PALAU SUNSET HARBOR

"FIRST SUBMITTAL", JULY 07,2020

- (1) FAÇADE TILE CHANGE TO A SMOOTH DESIGNER CEMENT PLASTER (STUCCO)**
- (2) INSTALL ARCHITECTURAL GUTTERS OVER RETAIL**

EXISTING SCUPPER CONDITION

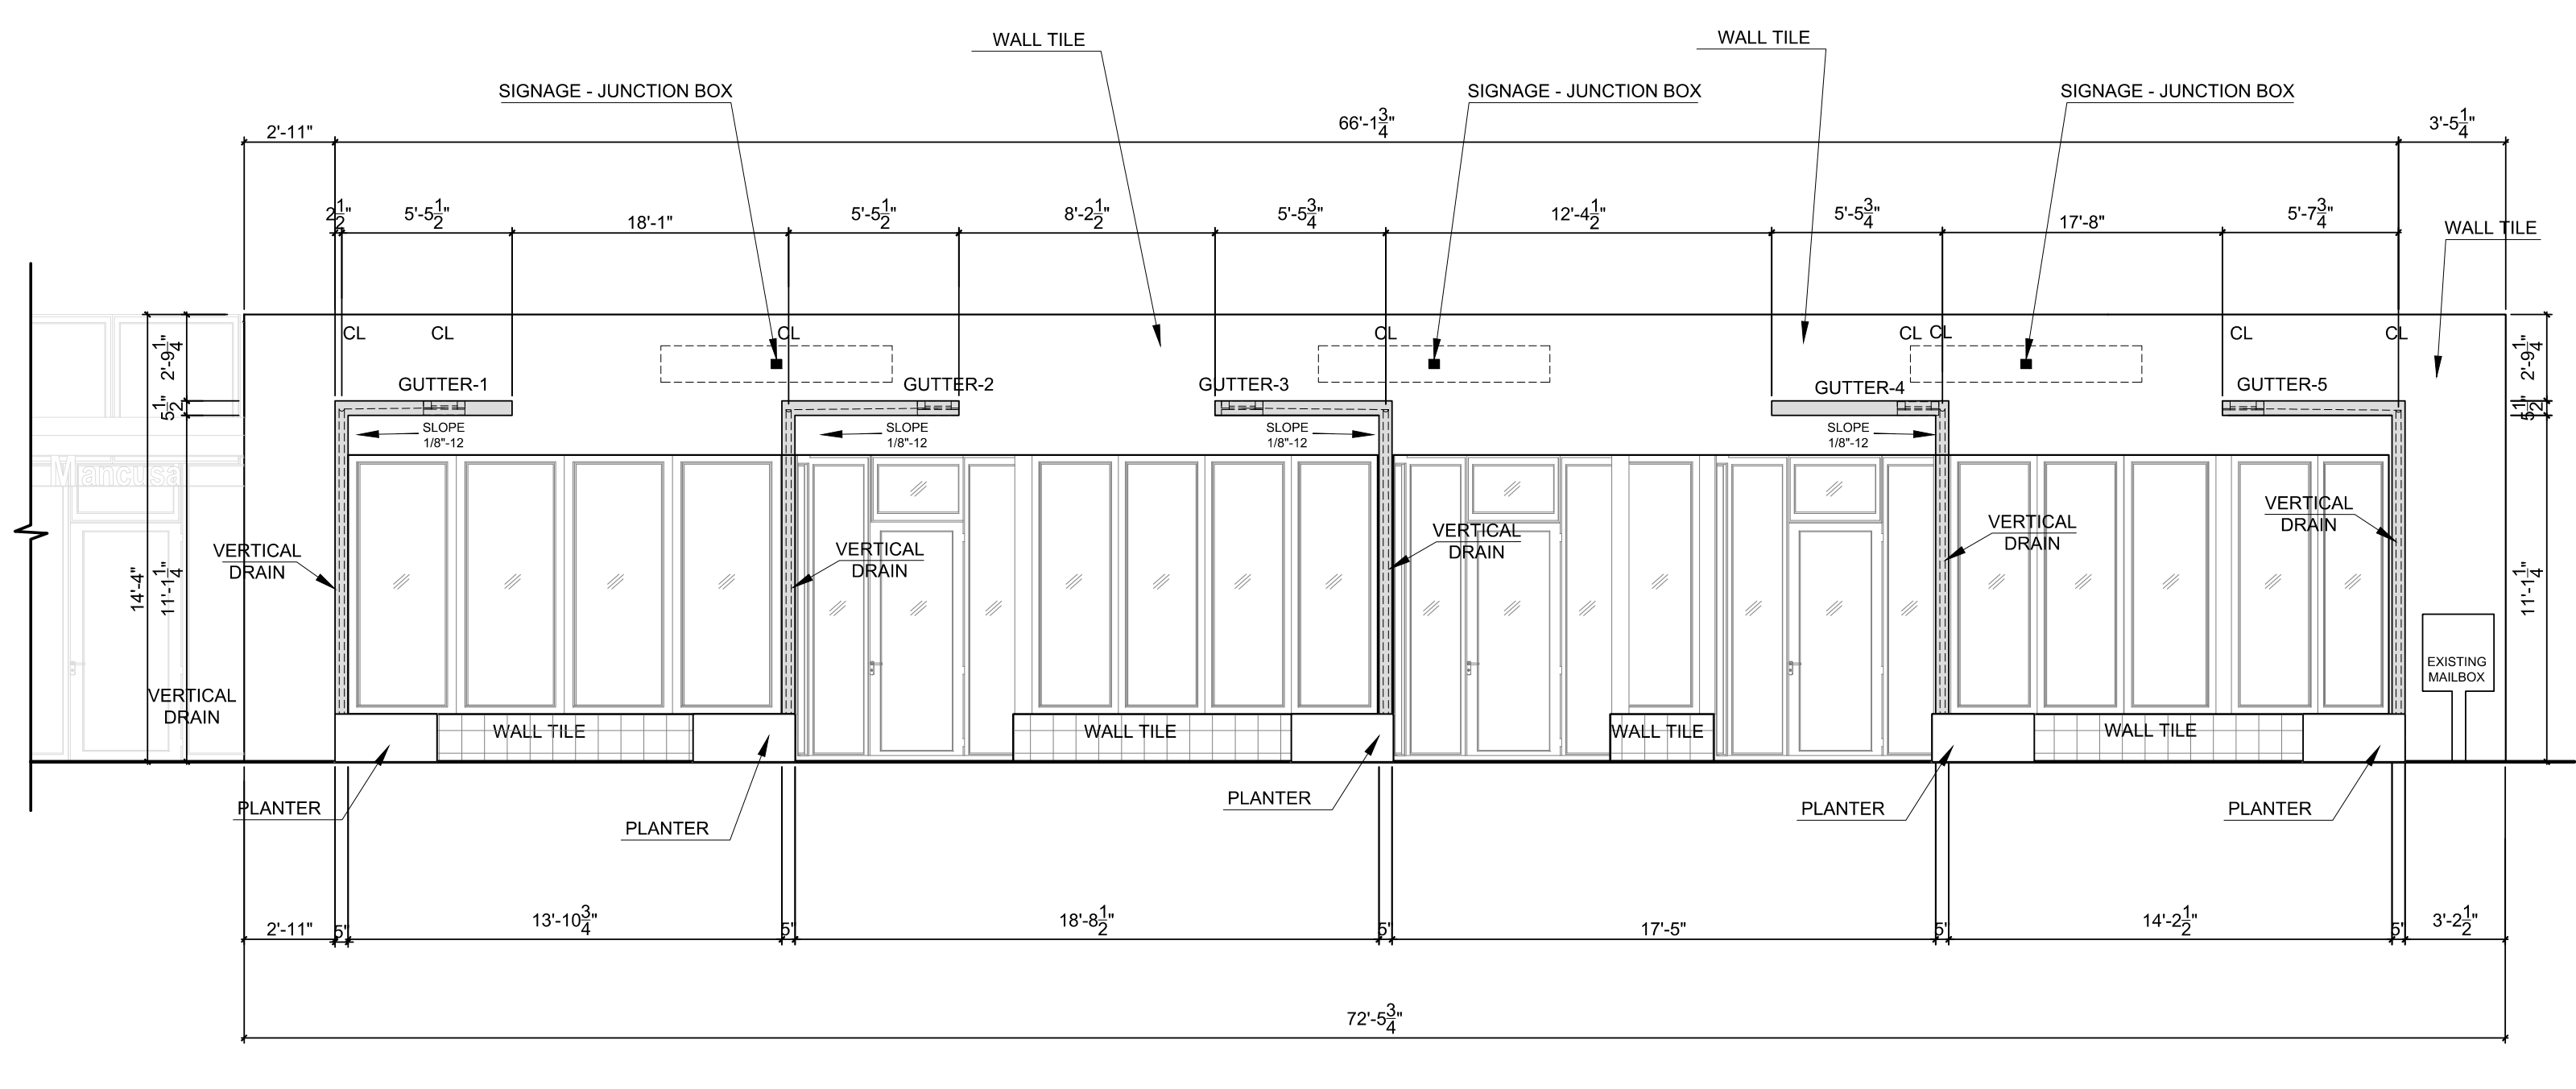
GUTTER PROPOSED SOLUTION
